DRAINAGE DESIGN AND ROAD
ALIGNMENT - PROVIDED BY CAPITA
/ JACKSON

Project
A29 Realignment Scheme

Drawing
Drainage Strategy Layout

Subject CS/099505 Drainage Strategy

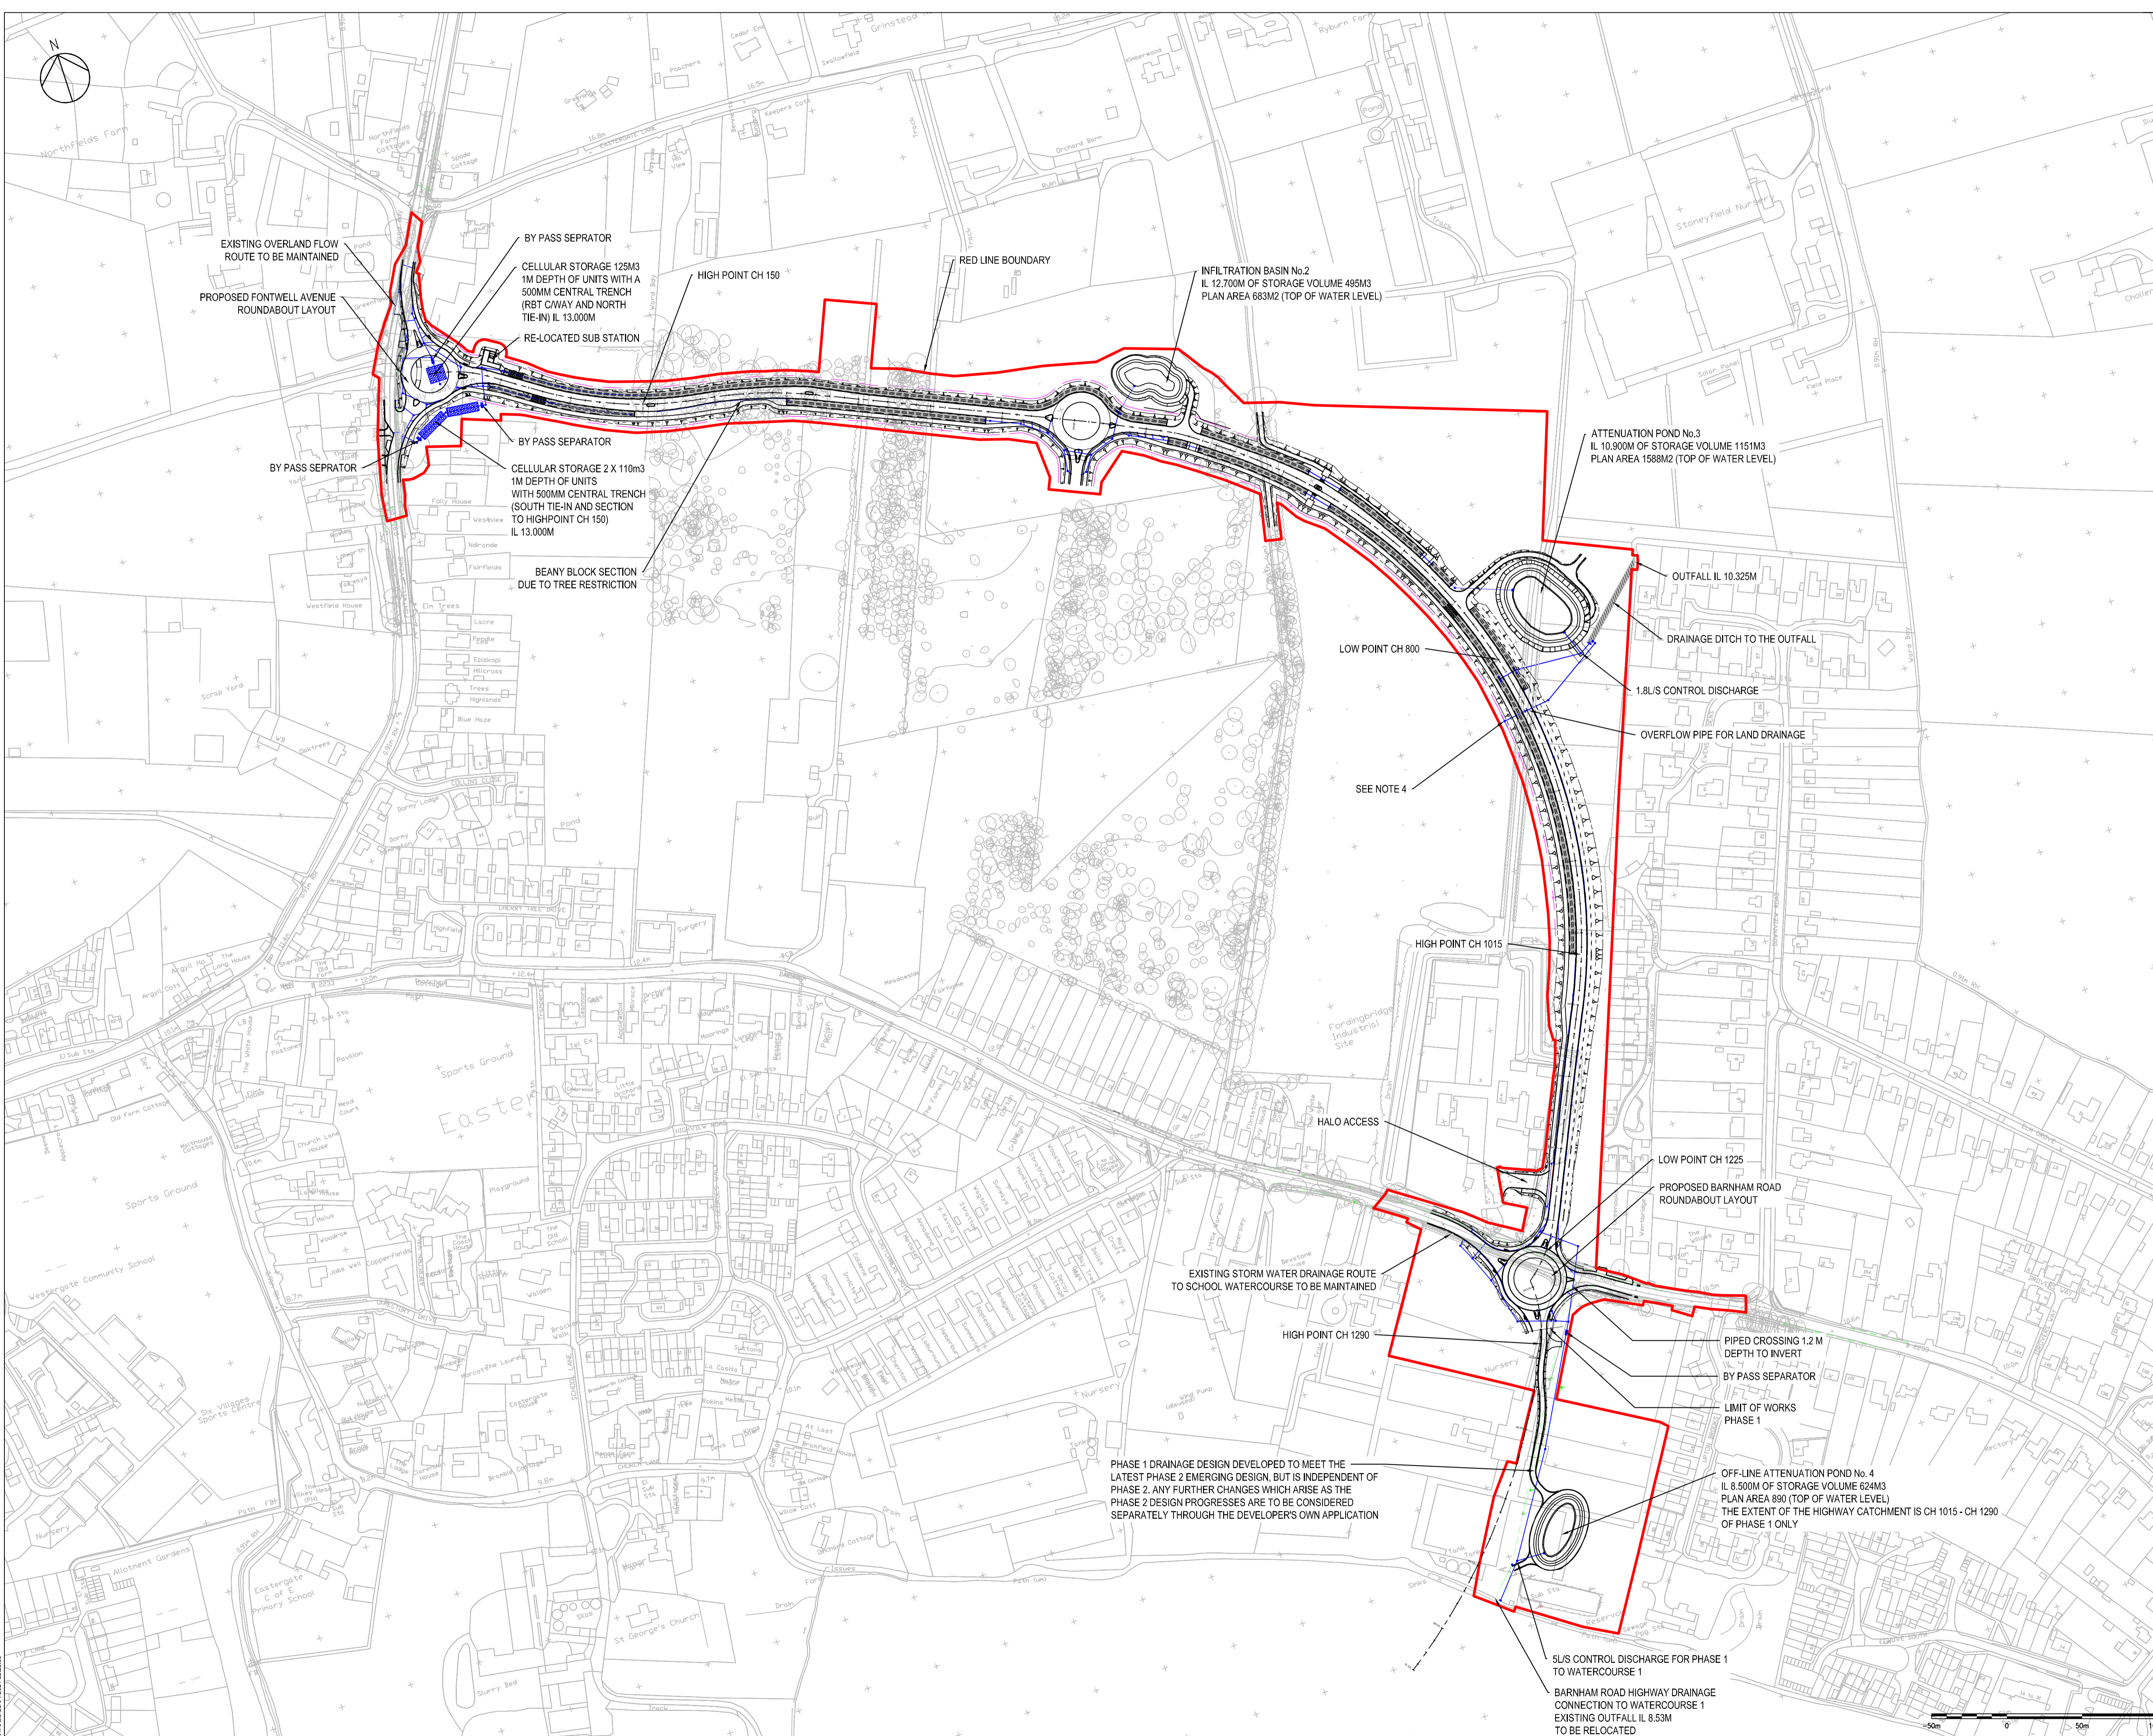
1. Our preference would be for open features as opposed to crates (pond/tank 1).
2. Discharge to the Barnham Lane ditch from pond 3 – restrict discharge to QBAR (ie. 1 in 2.3 year storm) bearing in mind the known issues downstream. I appreciate that this will need to be run past WSCC highways due to their min. 5 l/s discharge requirement, however, a hydrobrake in combination with upstream measures can be utilised to reduce any risk of blockage to the control, as that is probably their primary concern.

3. As I do not currently have access to the previous groundwater monitoring and infiltration testing data, please ensure that the worst winter infiltration rate achieved (at the proposed depth of the structure) at each pond location (ponds 1 and 2) is used and that peak winter groundwater levels are taken into account. Groundwater levels appear to arrange between 5m bgl and 2.124m bgl at the four pond locations and infiltration rates of 1.24×10^{-4} and 1.78×10^{-5} (at pond 1 & 2), according to the current Technical Note (March 2020). This will need to be verified against previous data received.

4. Whilst ponds 3 and 4 are relying attenuation/restricted discharge, infiltration must be utilised where ever possible in their respective catchment areas (taking into account item 3 above). A hybrid arrangement of infiltration and restricted discharge to watercourses is the likely solution.

5. Due to the shallow ditch to which pond 3 is going to discharge too, connection via a shallow channel/swale is probably going to be needed as opposed to pipework. Environment Agency approval will be required due to this section being 'main river'.

6. Has winter groundwater monitoring and infiltration testing been carried out south of Barnham Road, in order to inform the design of pond 4?

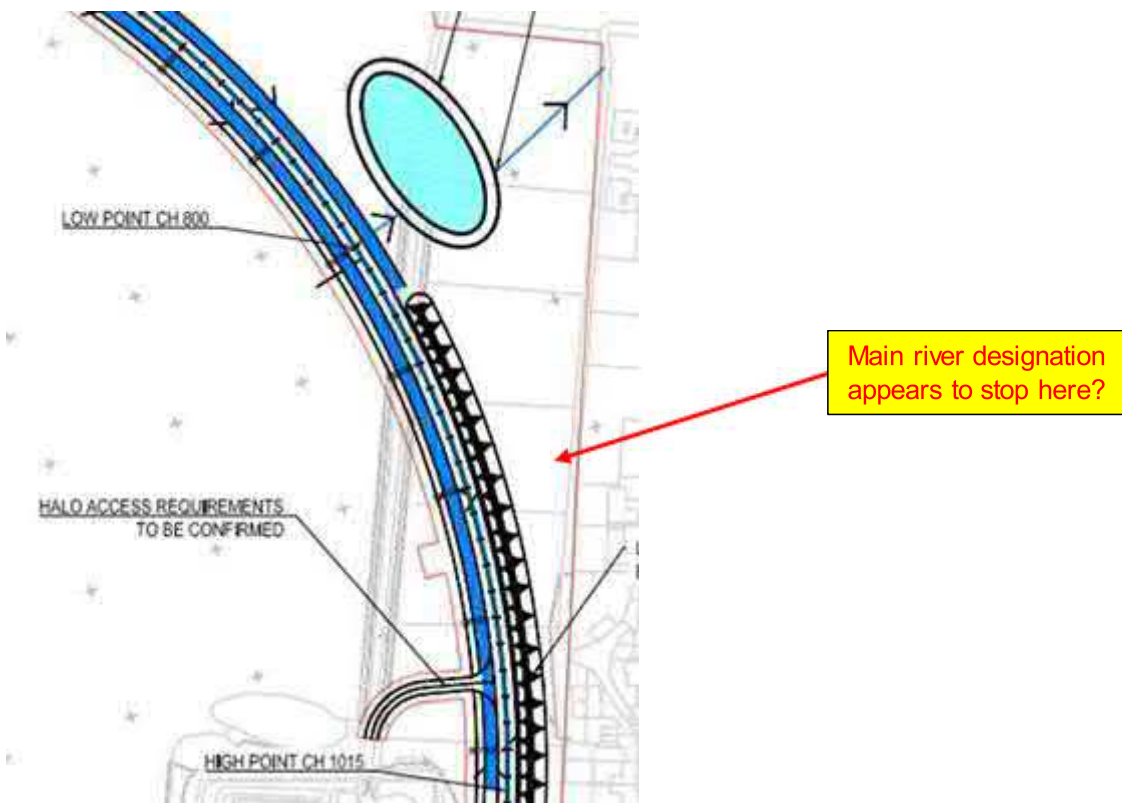
With regards to your comment concerning where the road route runs southwards past your main river (the blue line on your map with red arrow) – please can you explain further where you are referring to when talking about a culvert?

Seems our organisations have different meanings for the terms 'on line' When someone says 'on line' to the EA it's normally in reference to an existing watercourse whereas someone wishes to build a pond on line'of it. I can see from the plans that Pond 3 is not to be built on line of a watercourse, so therefore does not apply.

It is noted that in Capita's Drainage Strategy, reference is made to a Flood Risk Assessment (FRA) As a statutory consultee within the planning process this is not something that we have made comment on. There is potentially the tinniest amount of road shown as being possibly within the floodplain, although I really don't think it is significant enough to be having to look at any form of flood compensation. I would assume we will be consulted in due course when full details have been established.
